South Texas Project Electric Generating Station 4000 Avenue F – Suite A Bay City, Texas 77414

July 2, 2008
ABR-AE-08000048

South Texas Project
Units 3 and 4
Docket Nos. 52-012 and 52-013
Response to Requests for Additional Information

Reference: Letter, Paul Kallan to Greg Gibson, "Request for Additional Information, Letter Number One Related to the Environmental Report for the South Texas Combined License Application", dated May 19, 2008 (AE-ABR-08000097)

Figure 21. September salinity readings from navigational mile marker locations on the lower Colorado River compared to the mean monthly river flow rate, 2007-2008.

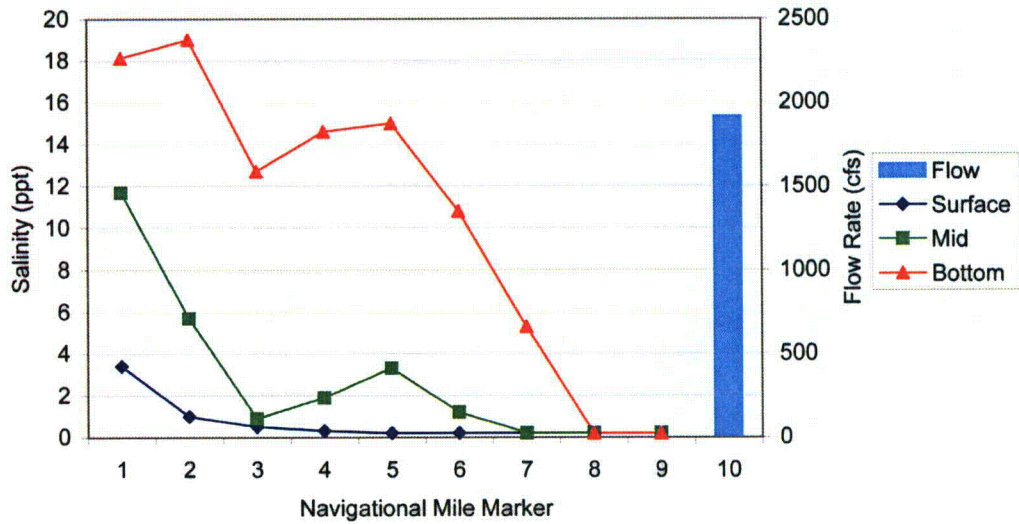
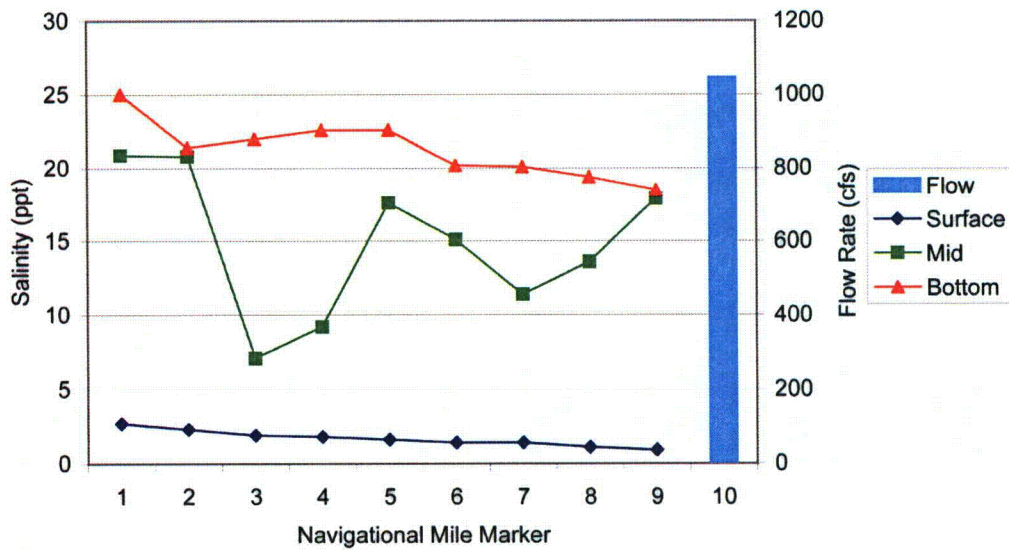
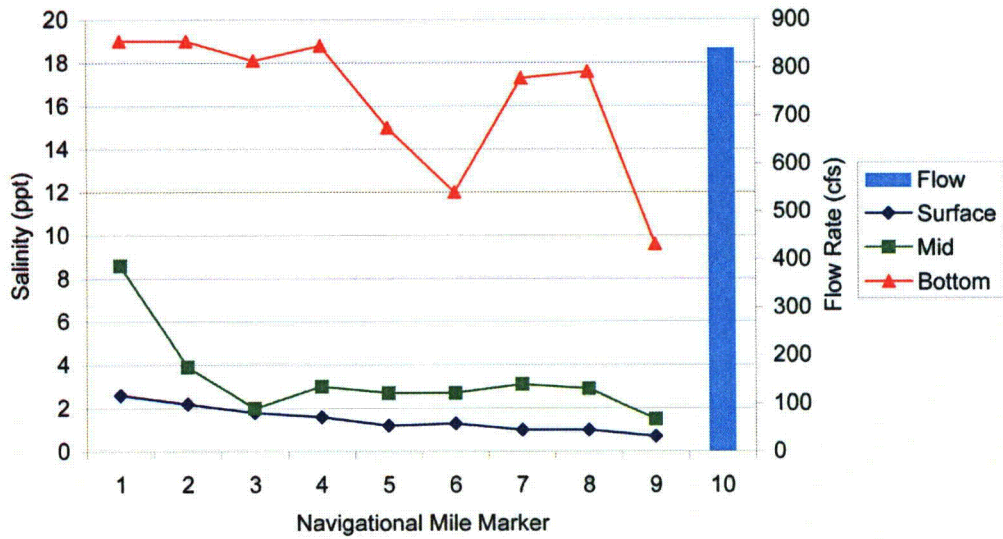
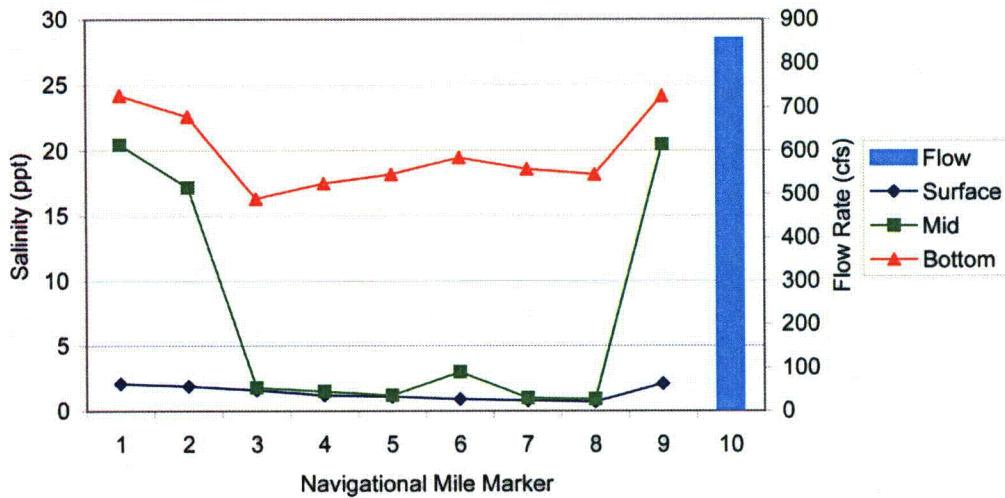
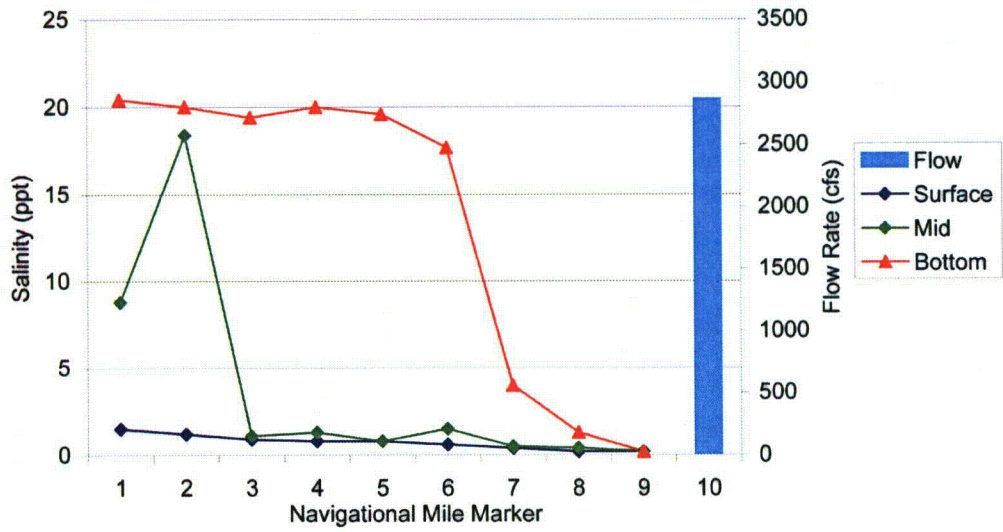
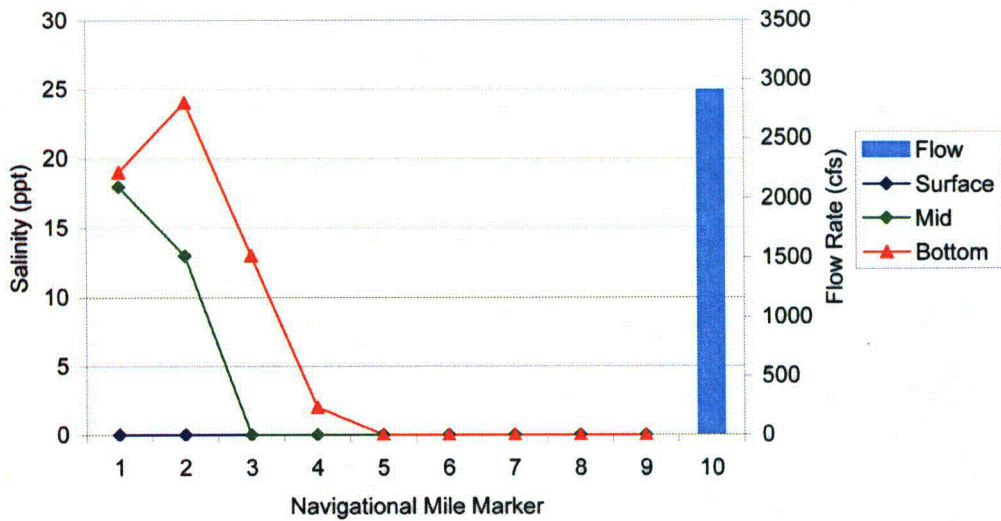
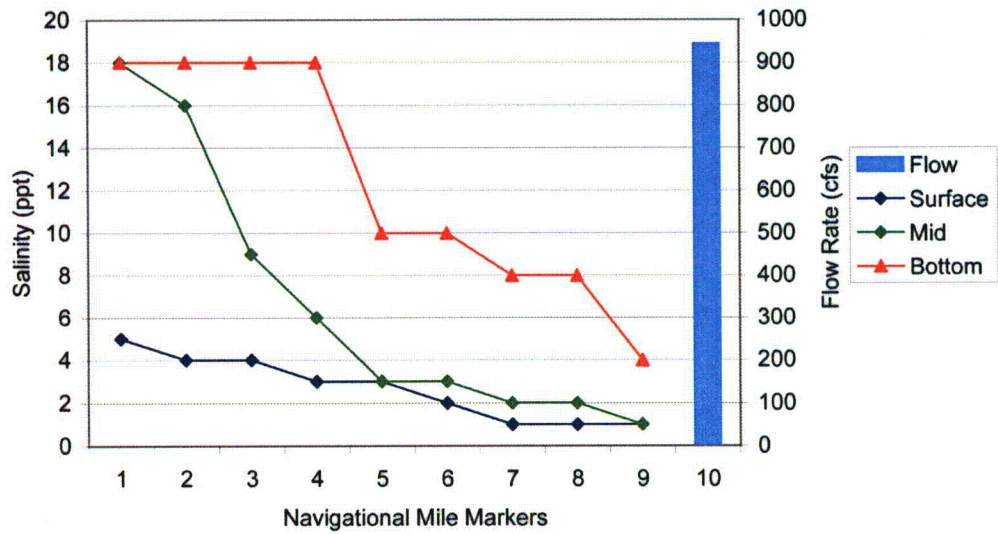
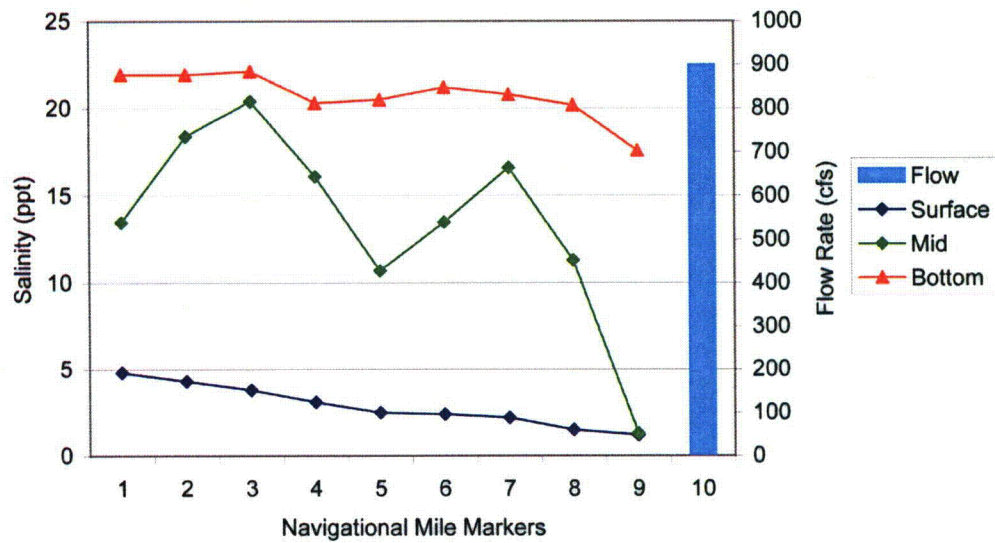
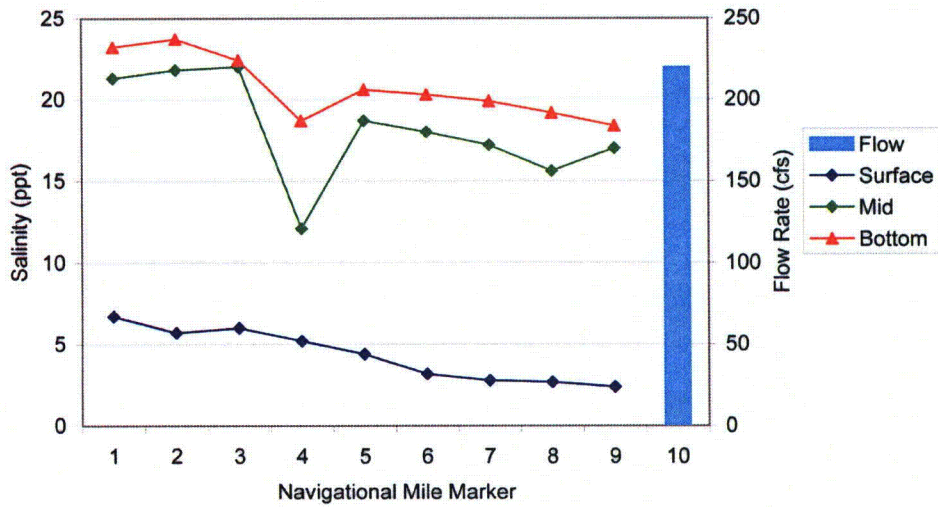
Provide pertinent data and information on the location of the salinity interface opposite the intakes in the Colorado River, and its position during different river flow conditions.

Figure 1.2-1 NRG Energy Corporate Structure

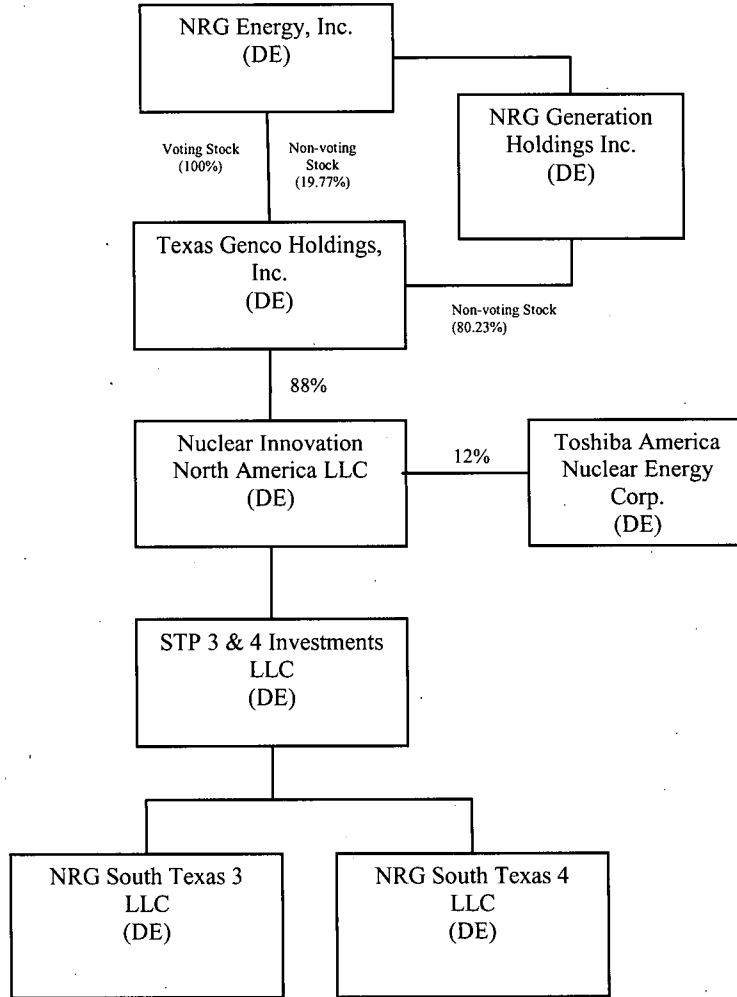
The existing ownership structure of these companies is reflected in Figure 1.2-1 and the ownership structure planned at the time a COL would be issued is reflected in Figure 1.2-2. Because Toshiba America Nuclear is only a minority (12%), non-controlling investor in an intermediate holding company in the corporate ownership chain of the NRG licensees, further detailed corporate information is not provided regarding the various direct, intermediate, and ultimate parent companies of the Toshiba America Nuclear.

Figure 1.2-1 will be revised as shown:

and Figure 1.2-2 will be deleted.

Throughout the remainder of the COLA, references to the owners of STP Units 3 & 4 will be to NRG Energy (or NRG) and CPS Energy (or CPS). Presentation of ownership entities will be made consistent with that described above in a future COLA revision. At that time, the information in COLA Part 1 Table 1.2-1 will be revised and updated for the entities shown in the revised Figure 1.2-1.
